ADDRESS : 741 [REDACTED]  
CONTRACTOR : CATES BUILDING INC  
OWNER : THE HARNETT LAND GROUP II LLC  
PARCEL : 03-9576-01- -0088- -82-  
APPL NUMBER: 14-50034279 CP NEW RESIDENTIAL (SFD)  
DIRECTIONS : T/S: 07/25/2014 09:17 AM JBROCK ----  
TINGEN [REDACTED]

STRUCTURE: 000 000 52X41 3BDR MONO W/ GARAGE

Re: J0714-3564

Job J0714-3564	Truss F2	Truss Type Floor Truss	Qty 3	Ply 1	Cav & Cates/170 Tingen Pointe/Hamett	E8436514
Comtech, Inc., Fayetteville, NC 28309		Job Reference (optional) 7 430 s Jul 25 2013 Mitek Industries, Inc. Wed Oct 29 13:59:21 2014 Page 1

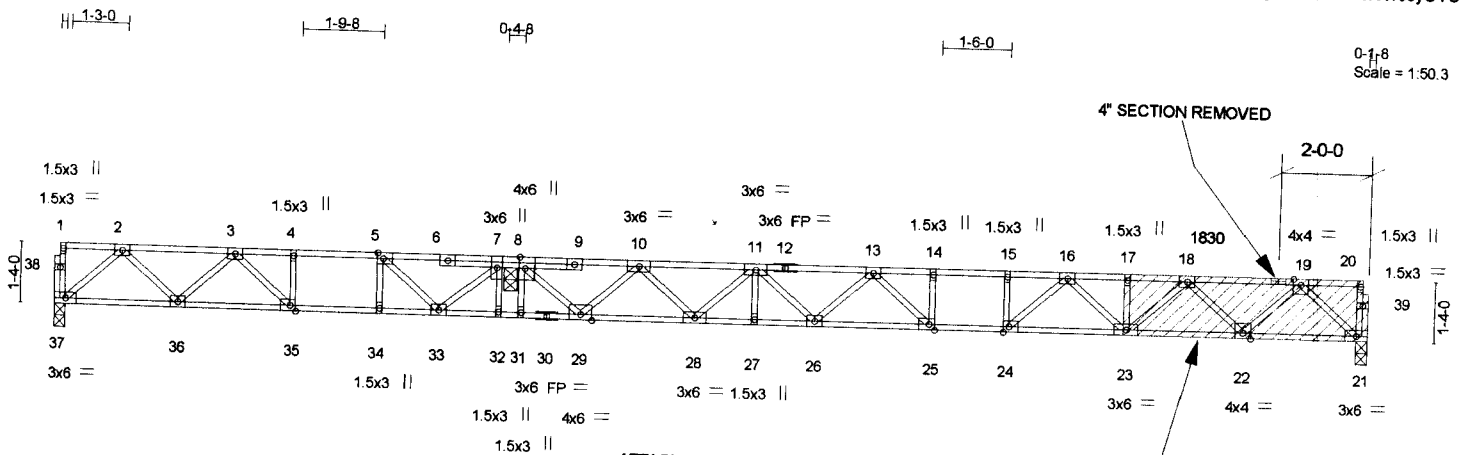
3- Strongback cut in kitchen

ATTACH 2 LAYERS 3/4" PLYWOOD OR OSB GUSSET (23/32" APA RATED SHEATHING 48/24 EXP 1) TO ONE SIDE OF TRUSS WITH CONSTRUCTION QUALITY ADHESIVE AND ONE ROW OF #12 (.216" DIA.) X 3" WOOD SCREWS SPACED 2" O.C. IN ALL MEMBERS. A 1/8" DIA. PILOT HOLE SHALL BE DRILLED FOR EACH WOOD SCREW. DO NOT USE DRYWALL OR DECKING TYPE SCREWS. GLUE PLYWOOD LAYERS TOGETHER PRIOR TO ATTACHING TO TRUSS.
